In 2008, the FAA released Change 1 for FAA-H-8083-15A, Instrument Flying Handbook (which was originally released in 2007). In Change 1, the following editorial changes were made that supersede the original release. Several illustrations were corrected, and they are printed below with the change instructions. In the text changes shown below, yellow highlighting indicates where an edit has occurred.

Figure 2-1. The Airfoil.

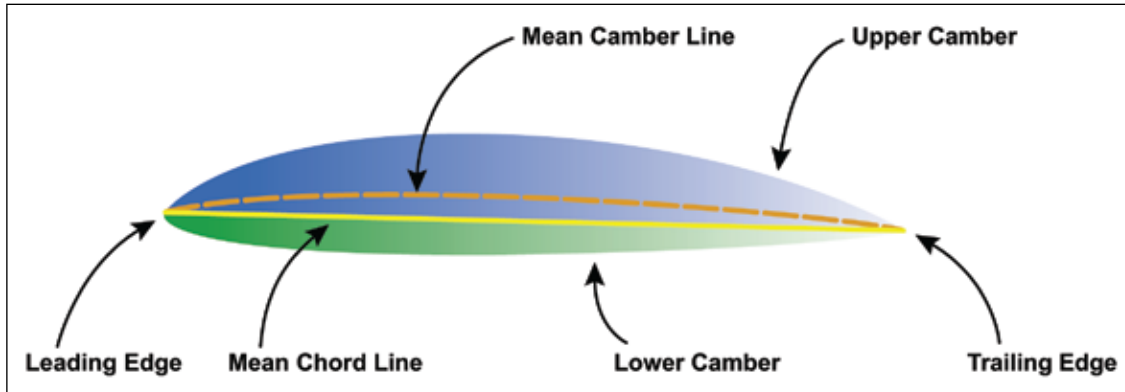
2-2	Figure 2-1 has been corrected:
-----	--------------------------------

Figure 2-15. Adverse Yaw.

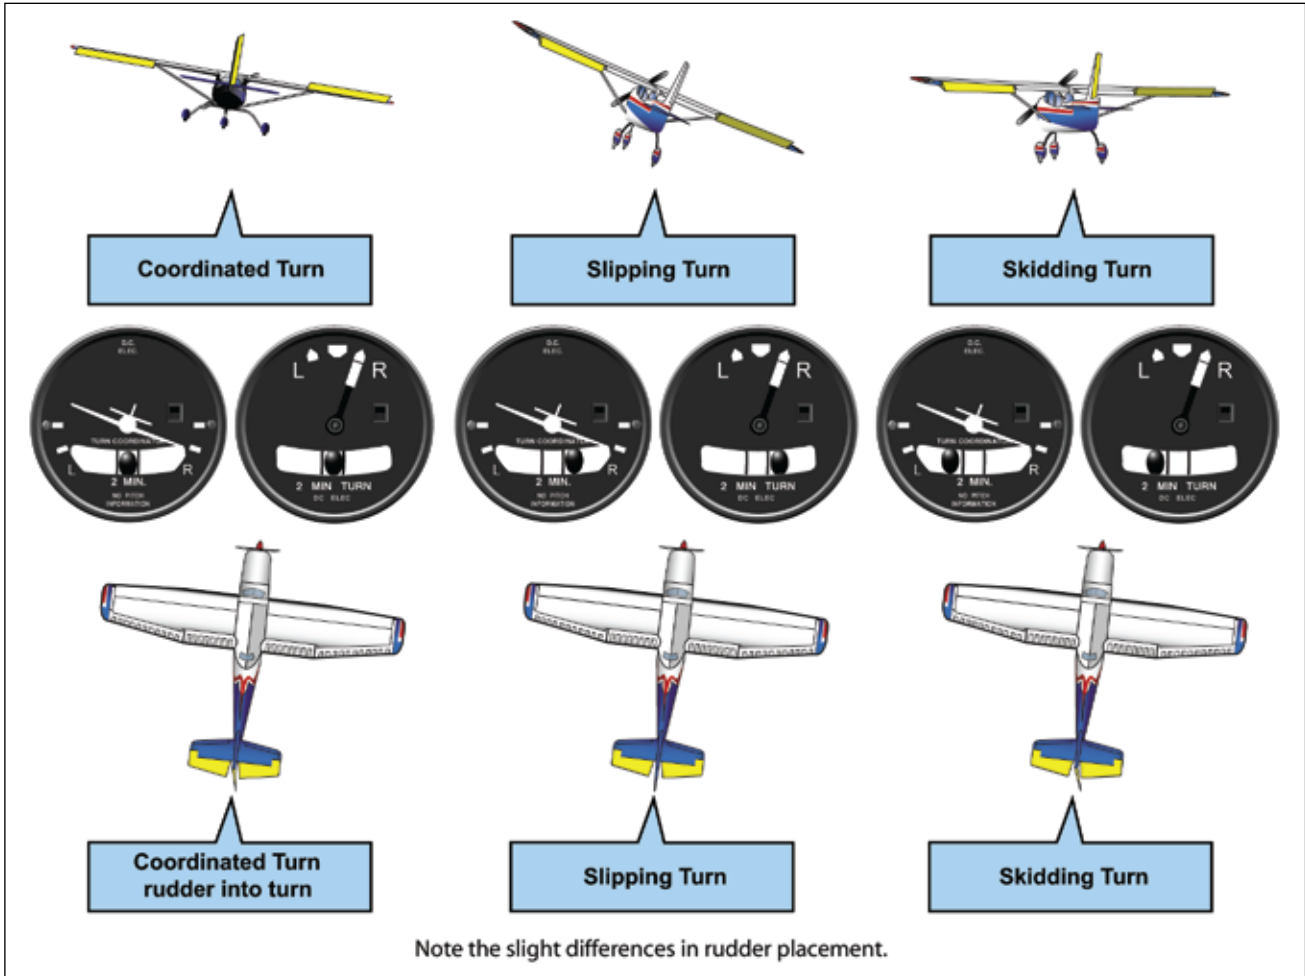
2-12 *Figure 2-15 has been corrected:*

Figure 3-3. Sensitive Altimeter Components.

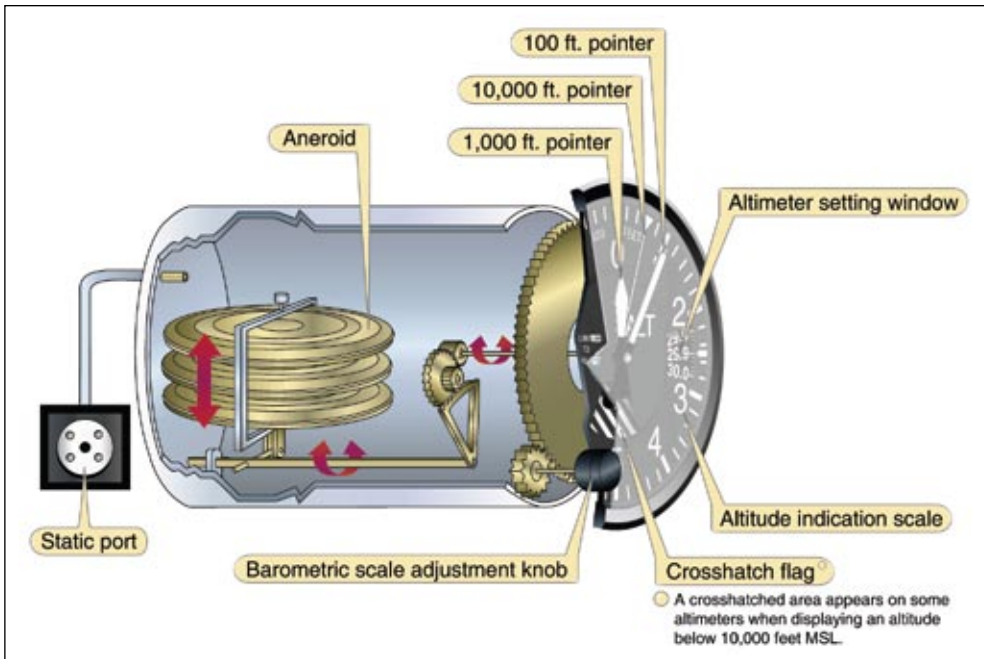
3-4 *Figure 3-3 has been corrected:*

Figure 7-7. ADF Tracking Inbound.

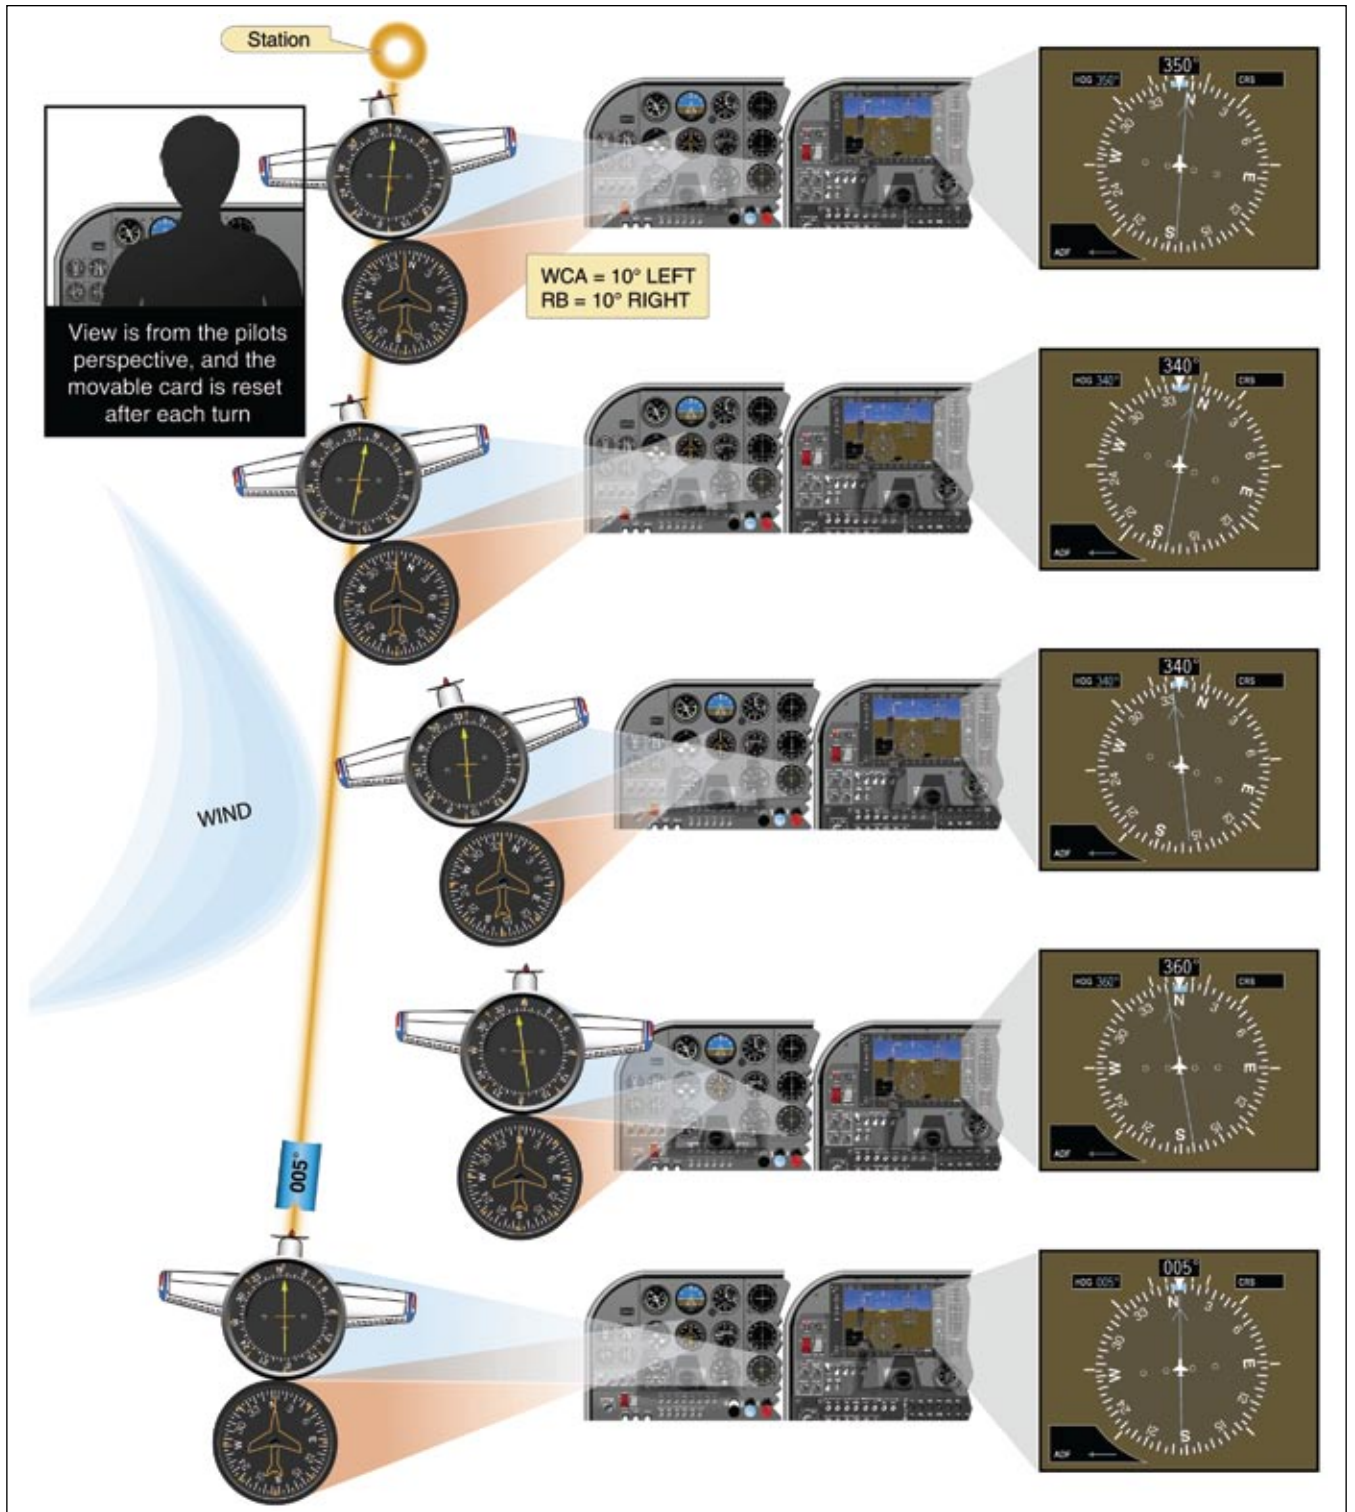
7-7 Figure 7-7 has been corrected:

Figure 7-37. Precision and Nonprecision ALS Configuration.

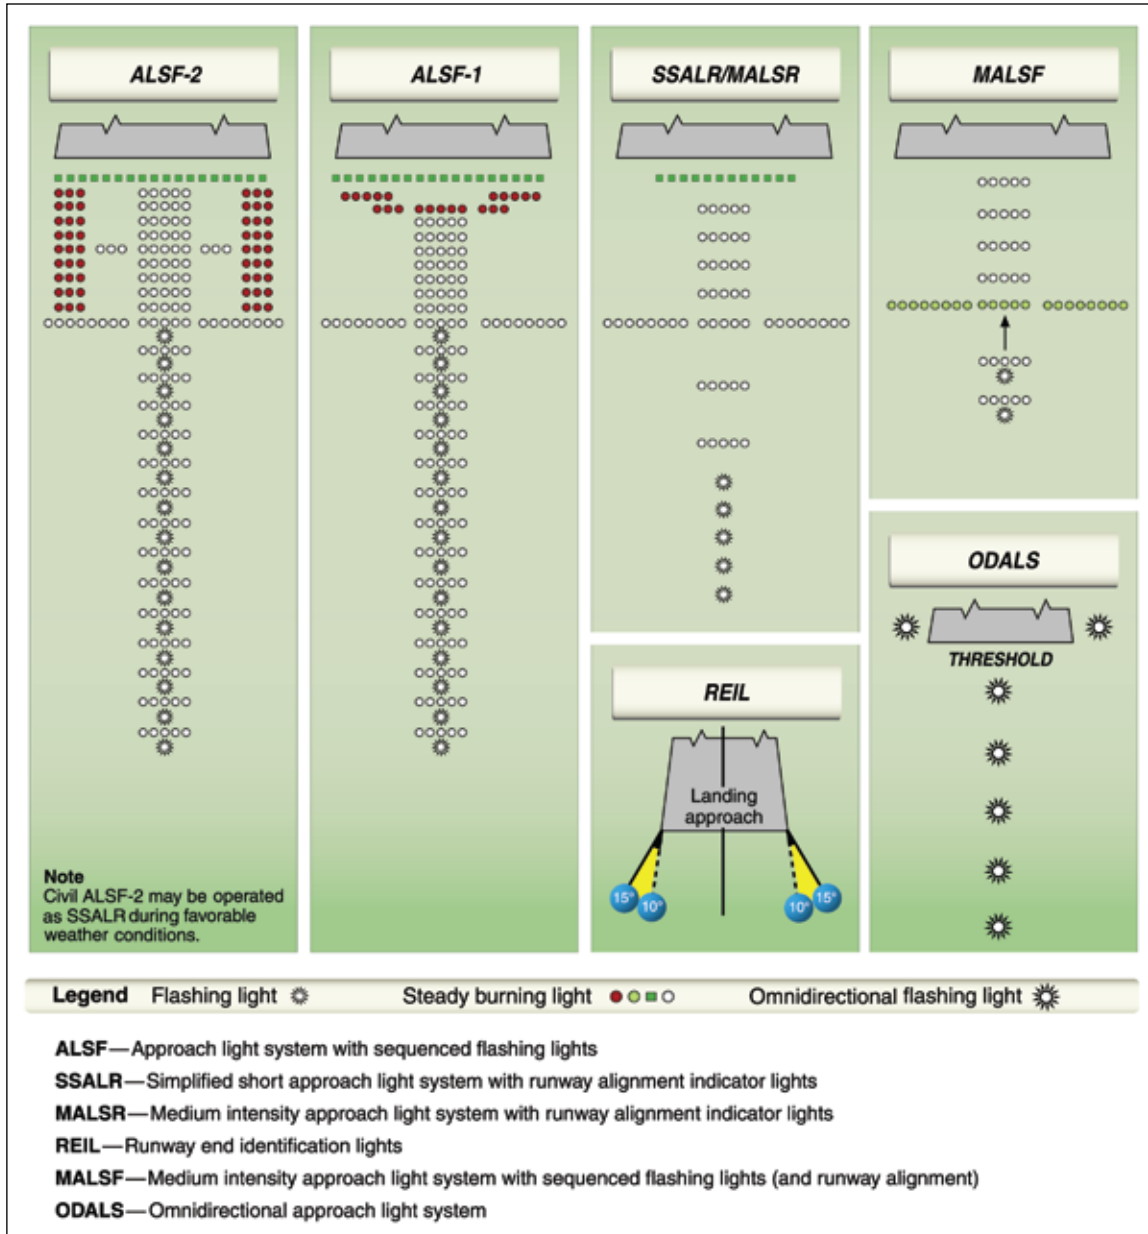
7-41 *Figure 7-37 has been corrected:*
